PLAN AND PROFILE

**KAMEHAMEHA HIGHWAY
WAIMEA BAY
EMERGENCY ROCKFALL REMEDIATION**

FEDERAL-AID PROJECT NO. STP-083-1(45)
Scale: As Shown Date: April 2000

SHEET No. 6 OF 39 SHEETS

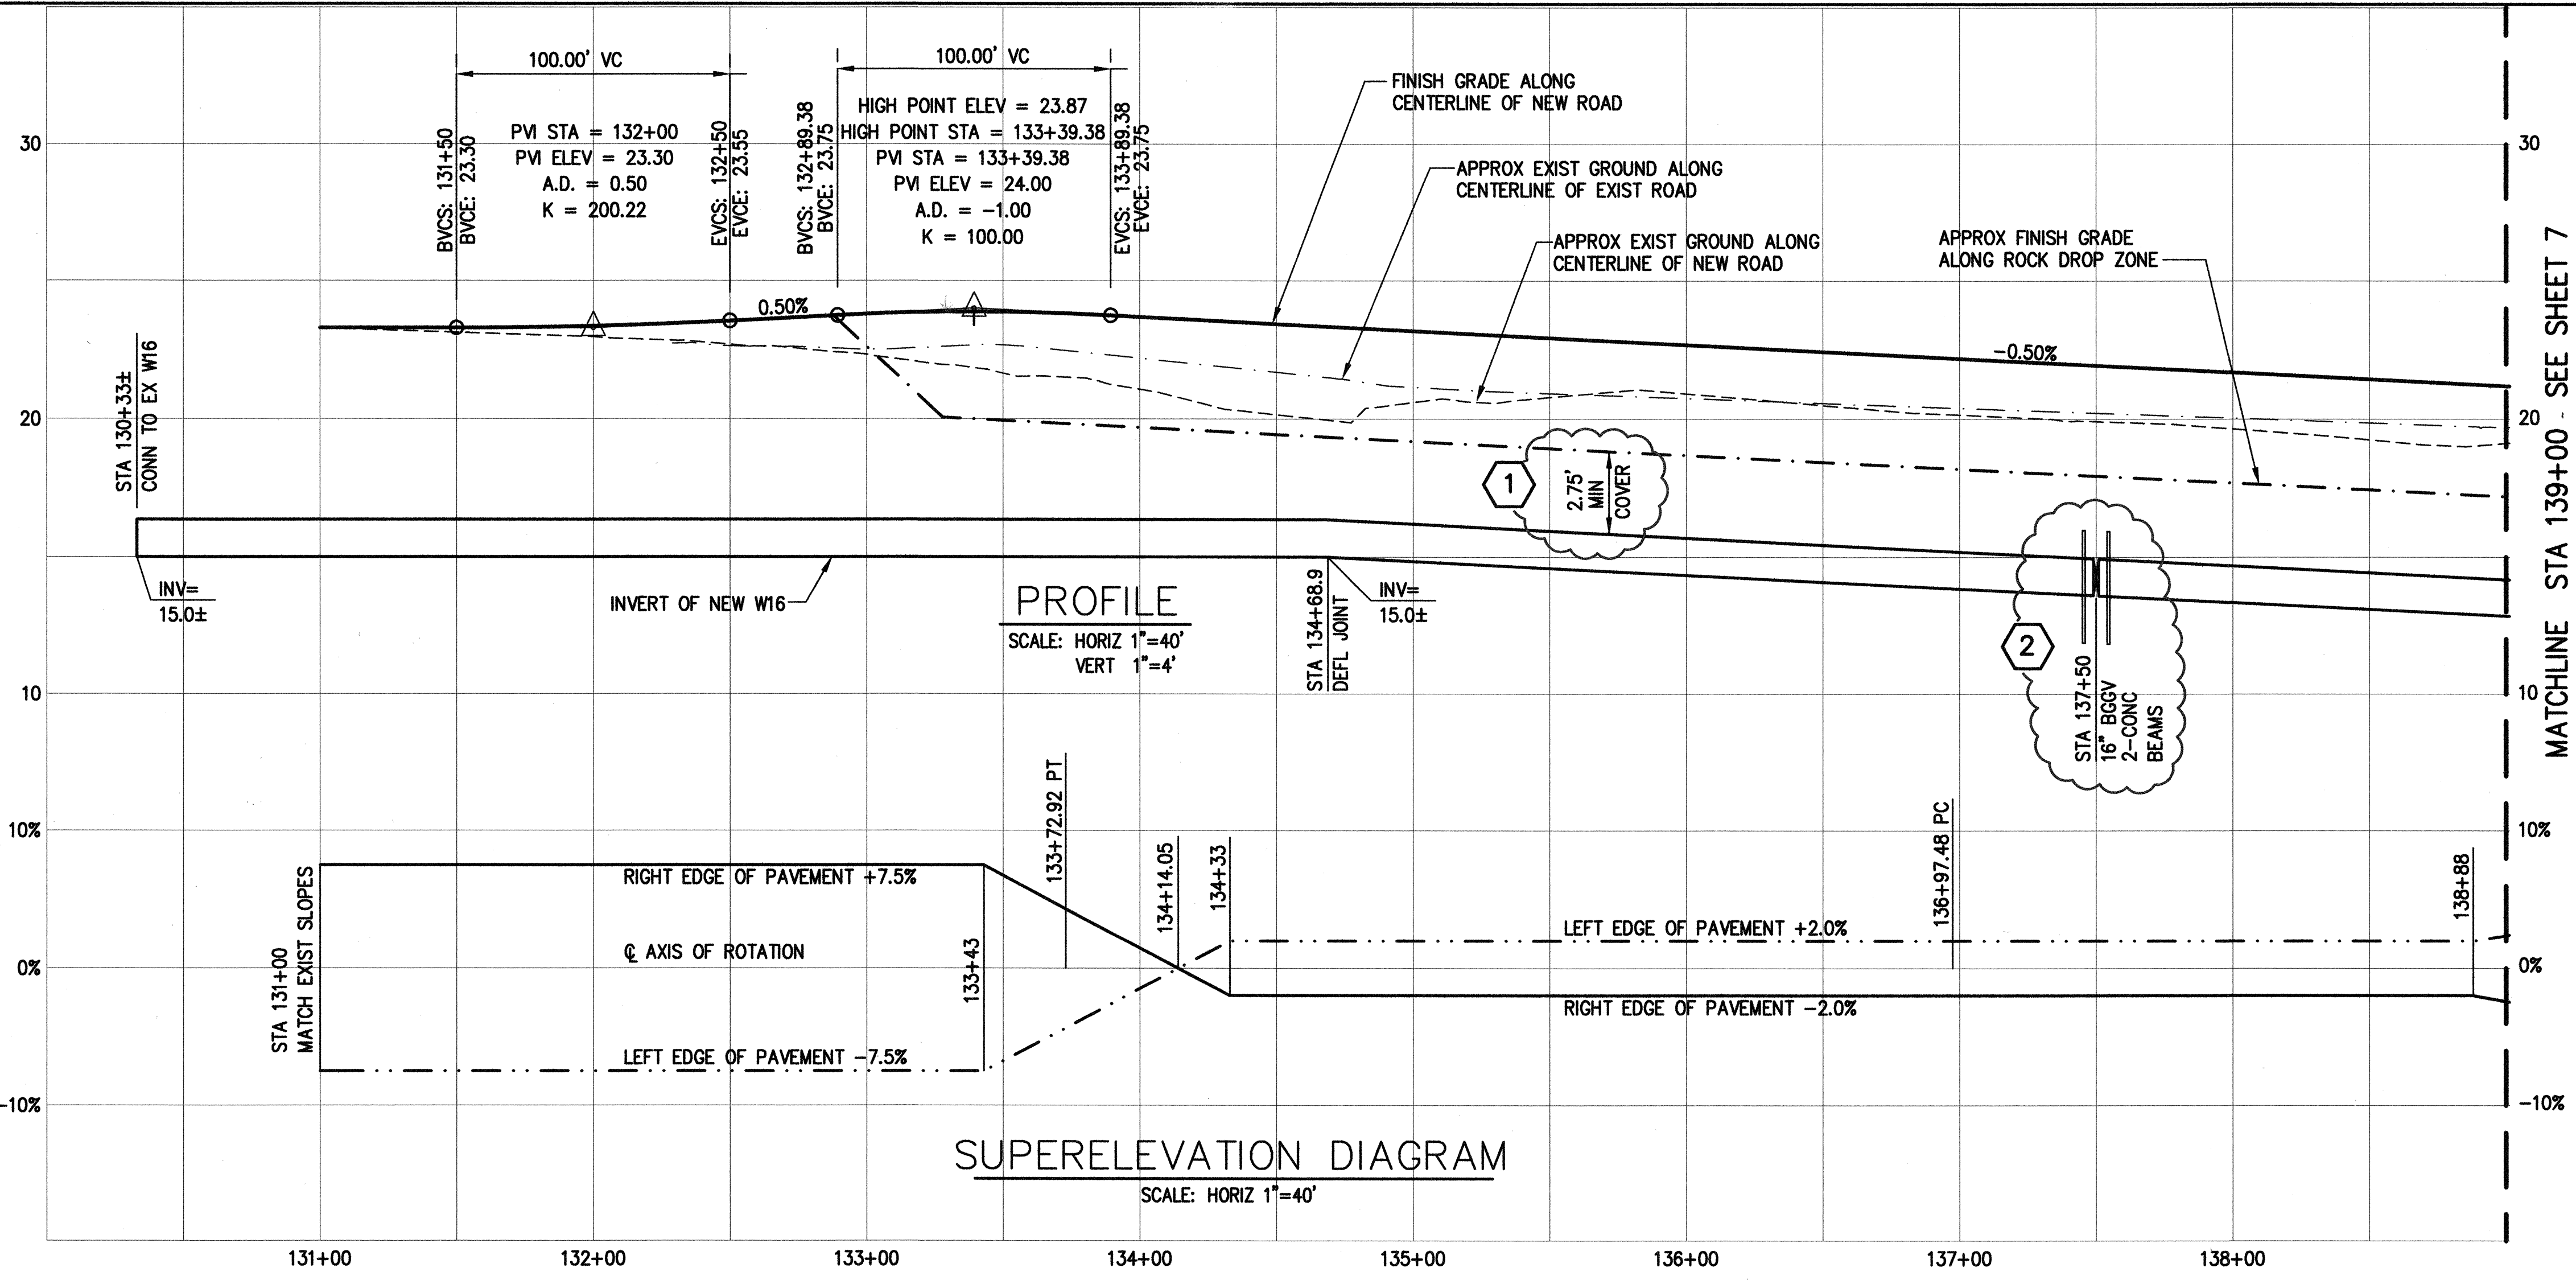
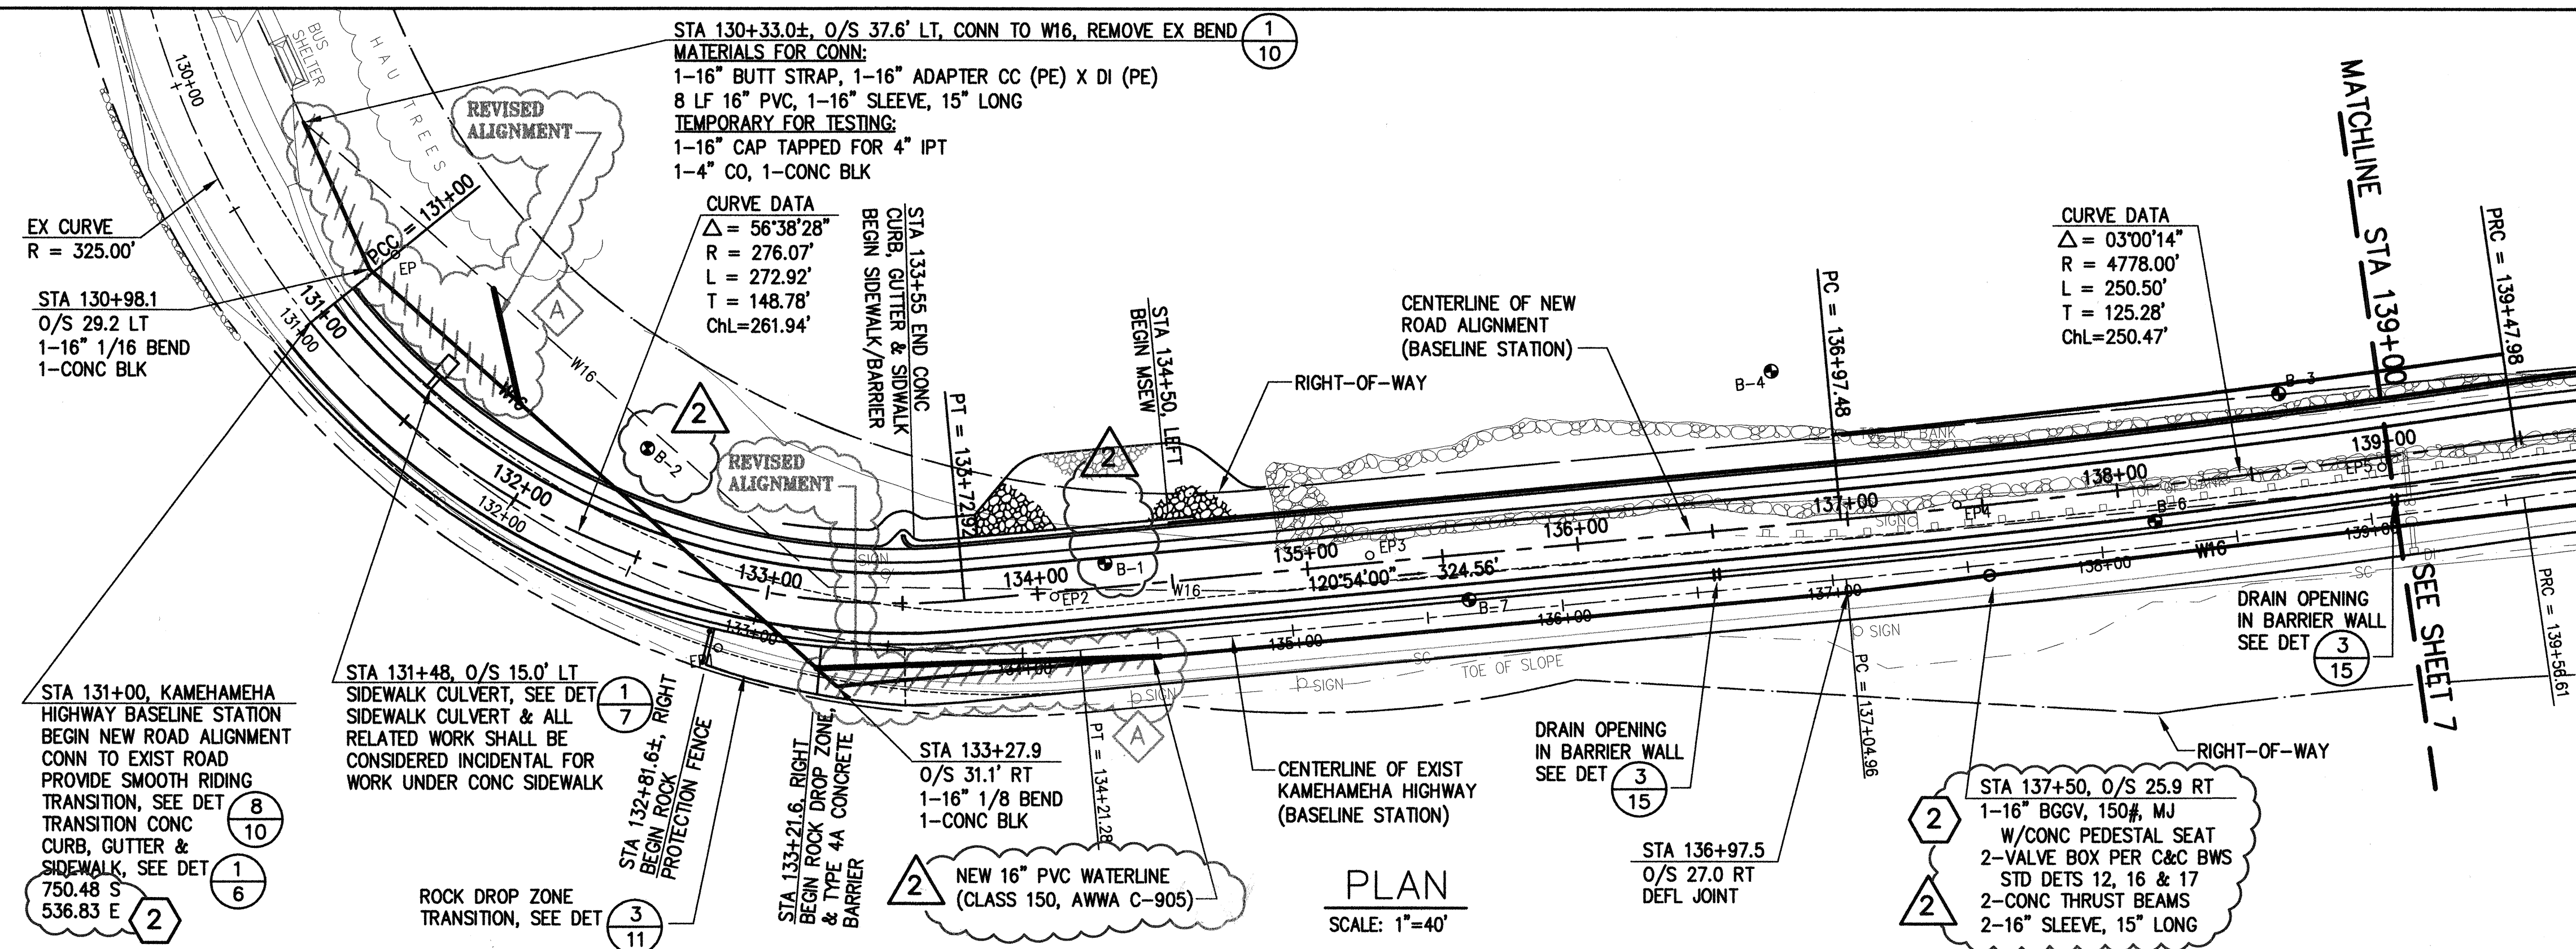
- NOTES:**
- STA 133+21.6, RIGHT & STA 141+50, RIGHT - INSTALL QUADGUARD (TL-2) ATTENUATOR (2' WIDE) WITH TRANSITION TO CONCRETE BARRIER. INCLUDED IN THE COST OF THE QUADGUARD IS THE TRANSITION TO THE CONCRETE BARRIER.
 - STA 143+20, LEFT - REMOVE EXISTING GUARDRAIL AS REQ'D FOR THE NEW ROADWAY PAVEMENT. INSTALL QUADGUARD (TL-2) ATTENUATOR (2' WIDE) WITH 4' WIDTH CLEARANCE FROM THE CONCRETE SIDEWALK/BARRIER FACE. THE QUADGUARD SHALL BE INSTALLED ON THE SIDEWALK WITH THE CONCRETE PAD AT GRADE. 80 LINEAR FEET OF THE NEW METAL GUARDRAIL SHALL BE USED TO TIE IN THE ATTENUATOR TO THE EXISTING METAL GUARDRAIL. INCLUDED IN THE COST OF THE QUADGUARD ATTENUATOR IS THE TRANSITION TO THE METAL GUARDRAIL.
